CITY PLANNING COMMISSION AGENDA

CPC ZC 15-00004 – QUASI-JUDICIAL

CPC DP 15-00005 – QUASI-JUDICIAL

PROJECT: THE LOOKOUT ON CRAGMOR

BUILDING ELEVATIONS
 DP07 of 11

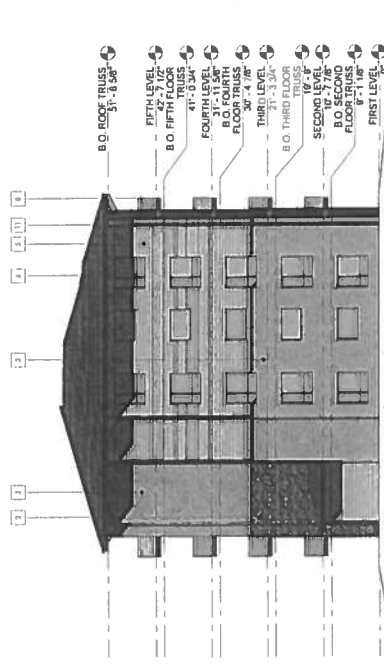
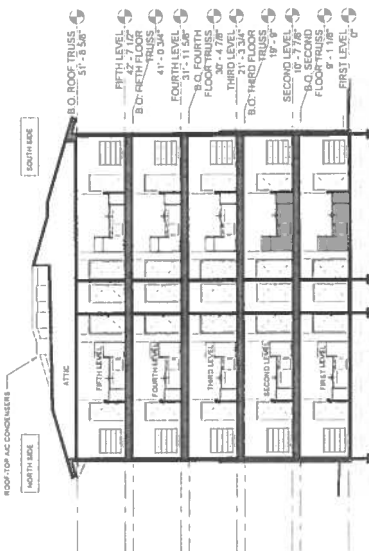
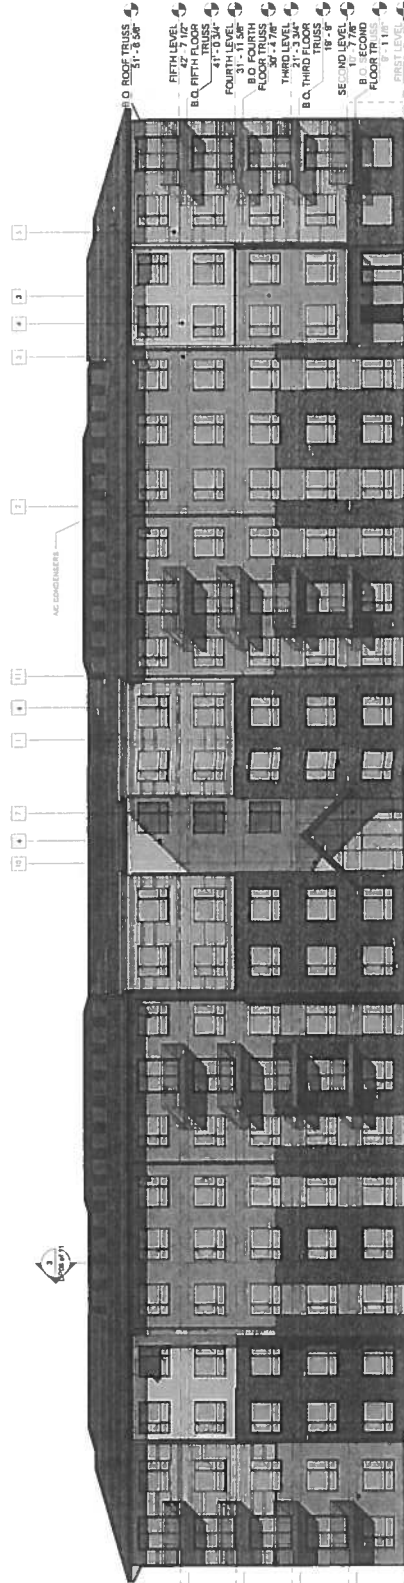
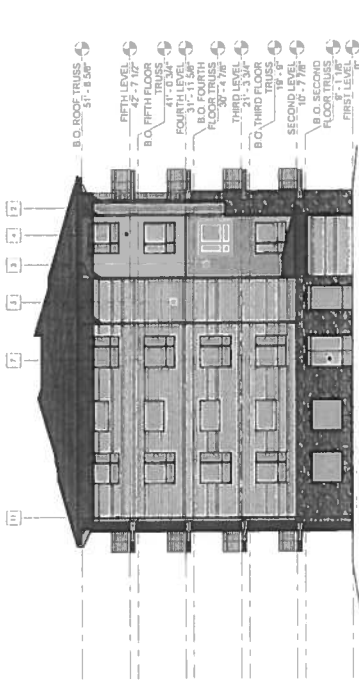
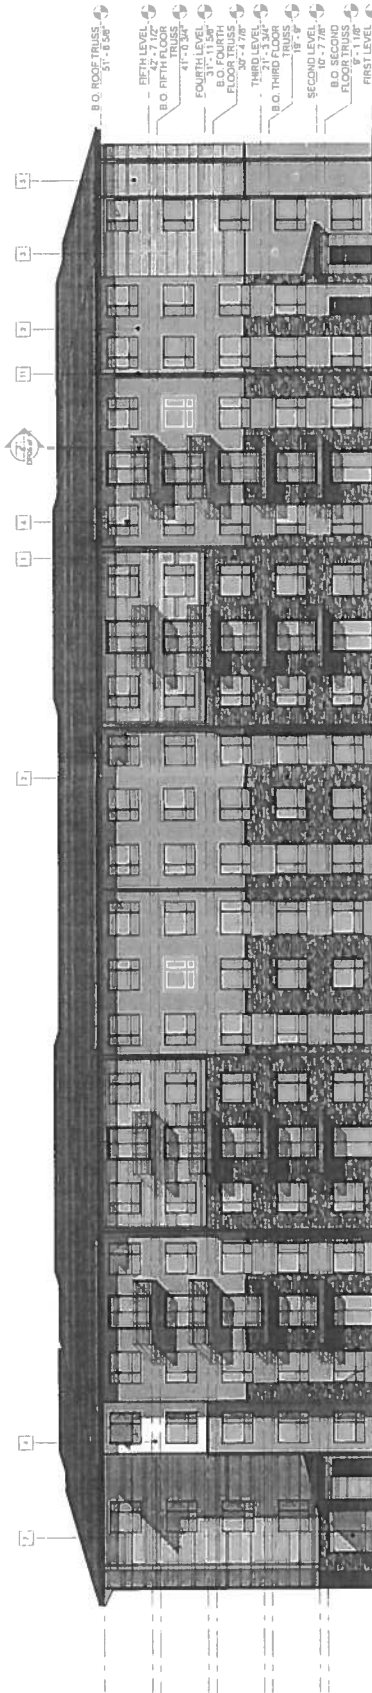
8. Note the height in feet of the highest portion of the roof (previously shown but deleted from revised plan).
9. Revise the photometric drawing to reflect the reduced height of the exterior lights.

- aa. On the elevation drawings show the location of the exterior lights attached to the walls. Note the use of full cut-off fixtures. To minimize light intrusion to the nearby residences reduce the height of the fixtures attached to the walls to 10' (presently noted as 15' on the south side of the building).

- bb. On the elevation drawings note the general colors of items 5 (lap siding), 9 (shingles) and 10 (metal roof).
- cc. Note the location of the equipment for the heating and cooling of the building. If rooftop equipment is proposed then show how the equipment is screened behind the roof structure.

COMPOSITE LEGEND:

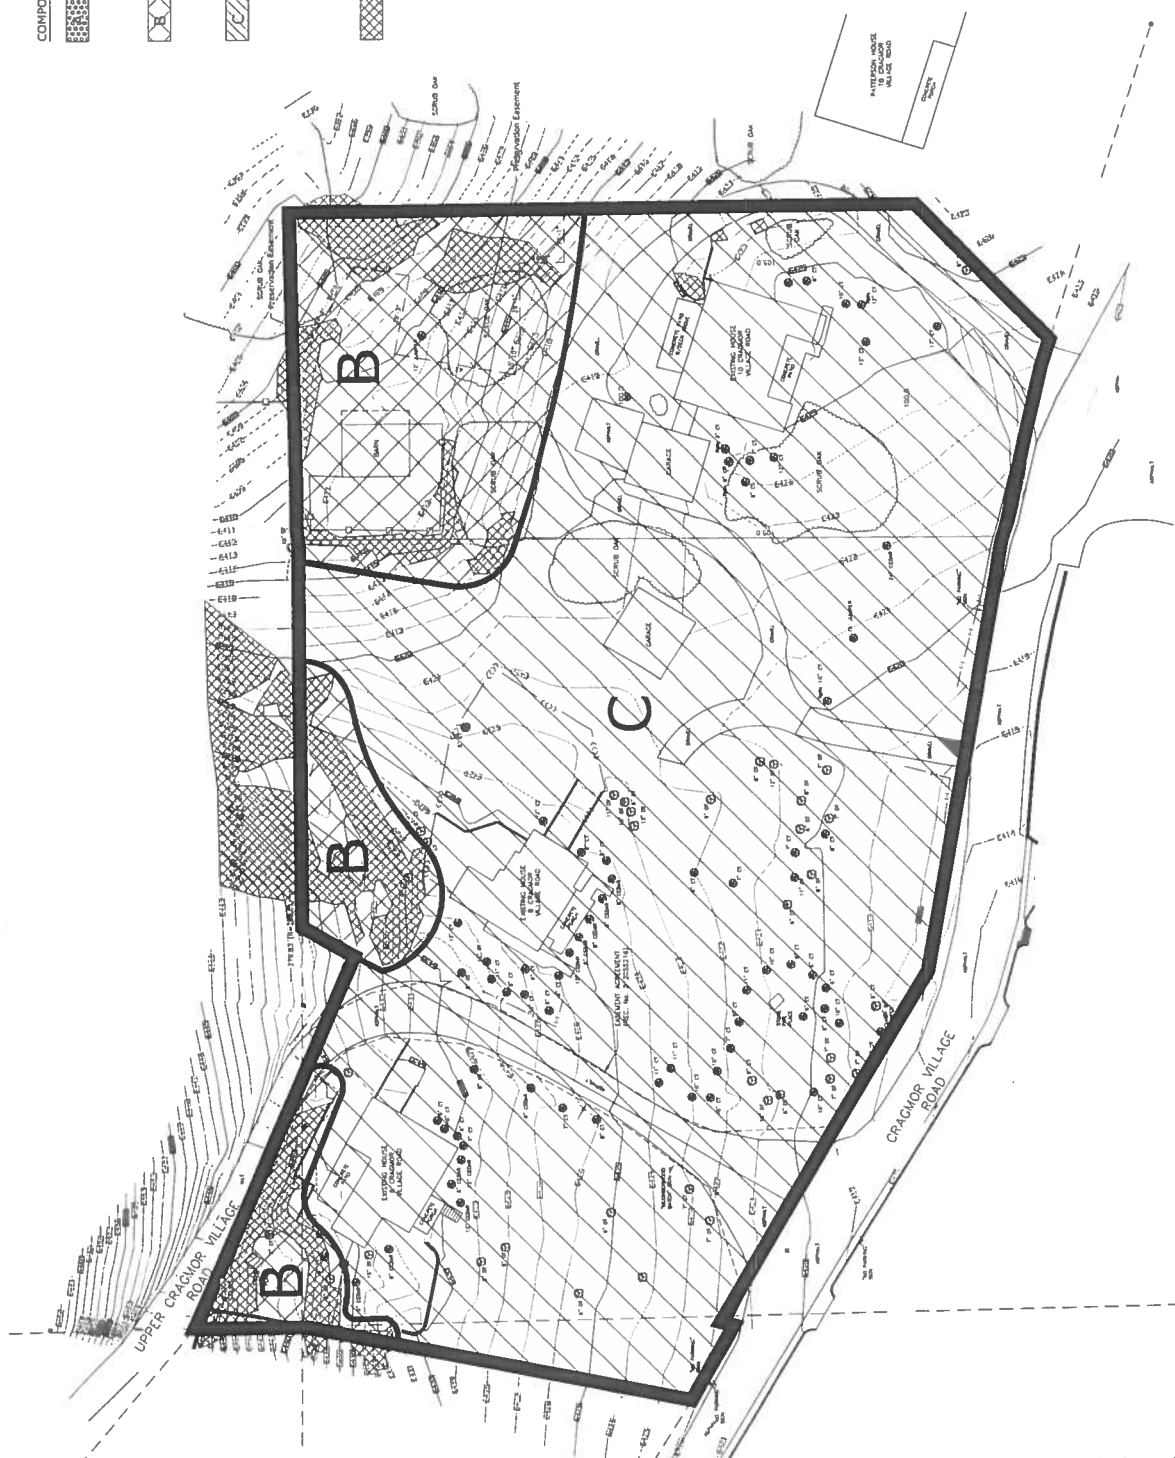
- hh. The land suitability analysis (sheet 13) shows within the B designated area in the northeast portion of the site slopes in excess of 25% and stands of native scrub oak. B areas are defined as areas with some development constraints. Section 7. 3.504.D.2.d.(1)(C) of the Zoning Code states "Slopes greater than 25% shall be avoided" within a Hillside Development Plan. The 2, B areas in the north and northwest portion of the site also contain slopes in excess of 25%, however these areas are not appropriate for preservation due to the man-made nature of the slope (fill for street) or do not include native vegetation such as scrub oak. Show the northeast portion of the site as identified on the attached sketch within a preservation area easement. Note the dimensions of the easement.

10. On sheet 4 note the preservation area in the northeast portion of the site as a preservation area easement. Note that prior to the issuance of either a building or grading permit the preservation area shall be fenced off from the remainder of the site and shall remain in place during construction.
